HUNTERS POINT ANNEX PHASE 1B ECOLOGICAL RISK ASSESSMENT WORKPLAN

SUBJECT: Review and Discussion of HPA Phase 1B Ecological Risk Assessment
Preliminary Work Plan
[PCA 14740 SITE 200050-45 OC 2:27]

Subject: HUNTER'S POINT ANNEX (HPA), PHASE 1B ECOLOGICAL RISK
ASSESSMENT, PRELIMINARY DRAFT WORKPLAN

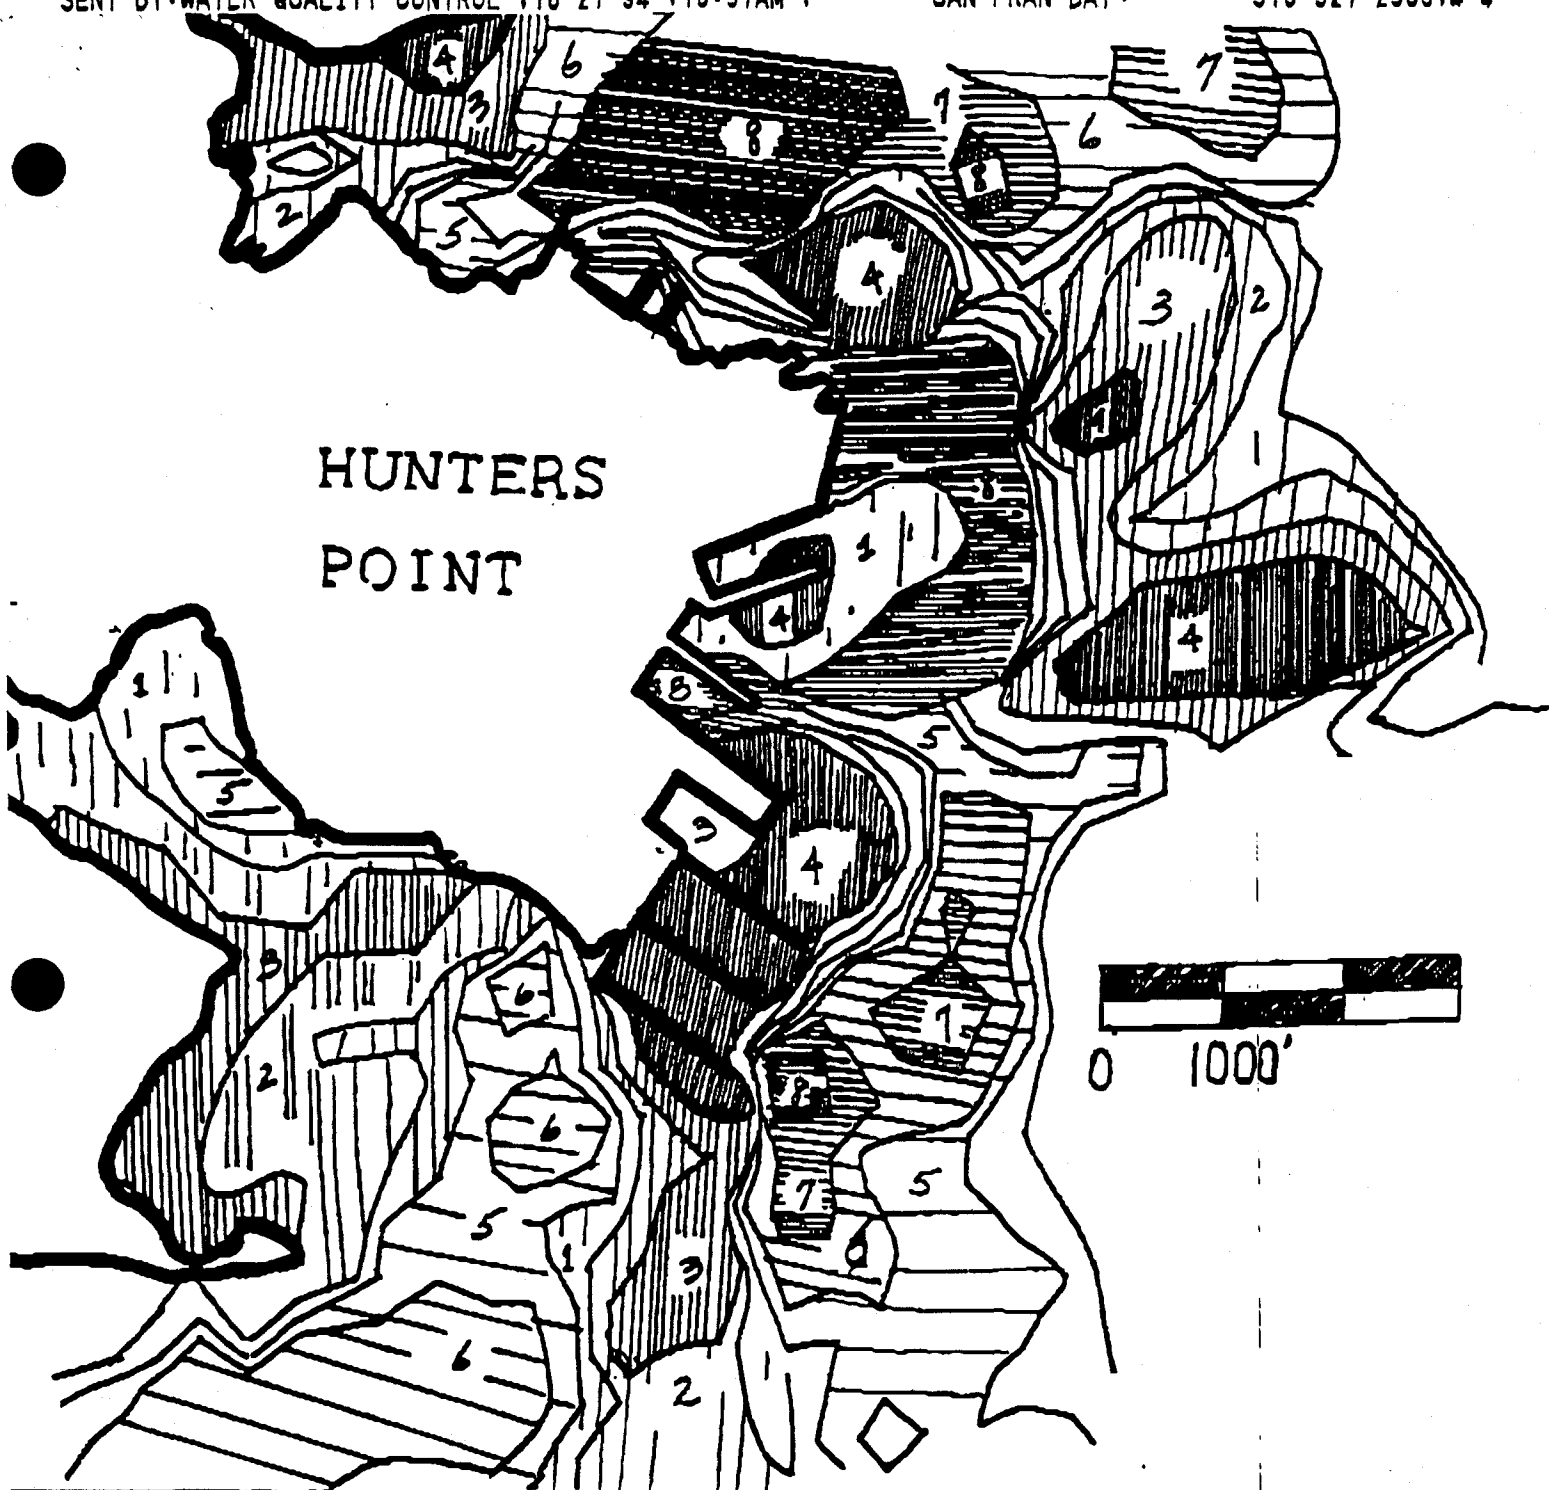
Reports reviewed by the San Francisco Regional Water Quality Control Board (SFRWQCB), particularly a report titled *Sediment Budget Study for San Francisco Bay, Final Report, February 29, 1992*, indicate there is substantial variation in rates of sediment deposition and erosion at HPA. Sediments with relatively high contaminant concentrations appear associated with areas of deposition while areas of erosion appear to have lower sediment concentrations. In general, the areas on the north of HPA appear to be erosional environments while the areas to the south, particularly off Parcel E, are depositional environments (map attached). The regulatory agencies agreed with the proposal that stormwater outfalls are the most probable transport path for the bulk of contaminants from the terrestrial portions of HPA to the sediments surrounding HPA during the operating period of HPA and therefore an appropriate place to focus Phase 1B investigations of threat to aquatic receptors. Sediment sampling locations, particularly those for vertical cores, should concentrate on the depositional areas identified in *Sediment Budget Study for San Francisco Bay* and other readily-available sediment reports, with less concentration on the areas of erosion. Concurrent with the Phase 1B investigation, the U.S. Navy and Navy contractors should identify reports or investigations which contain additional characterization of the erosional and depositional areas of HPA. This additional information on sediment erosion or deposition will then be used to evaluate the results of the Phase 1B superficial and at-depth sediment sampling. The Phase 1B sediment sampling and testing are designed to evaluate the existing threat posed by exposed sediments at HPA in addition to any vertical distribution of sediment contaminants associated with historic operations at HPA. There appear to be two somewhat distinct questions regarding the exposed sediments at HPA:

The planned sediment sampling and testing should be amended as outlined above. Additional discussions are needed to determine the orientation of the outfall transects and transect-specific sampling locations based on the information contained in the document titled *Sediment Budget Study for San Francisco Bay, Final Report* and other readily-available sediment reports. Concurrent with development and implementation of the Phase 1B investigation the U.S. Navy and Navy contractors should gather any additional data or reports regarding sediment deposition and erosion to aid interpretation of the Phase 1B sediment results. The arrow goby bioassay should be performed at all locations where other bioassays are performed. Office of Scientific Affairs comments on aspects of the *Phase 1B Ecological Risk Assessment Preliminary Draft Work Plan*, dated October 4, 1994 will be furnished in a separate memorandum.
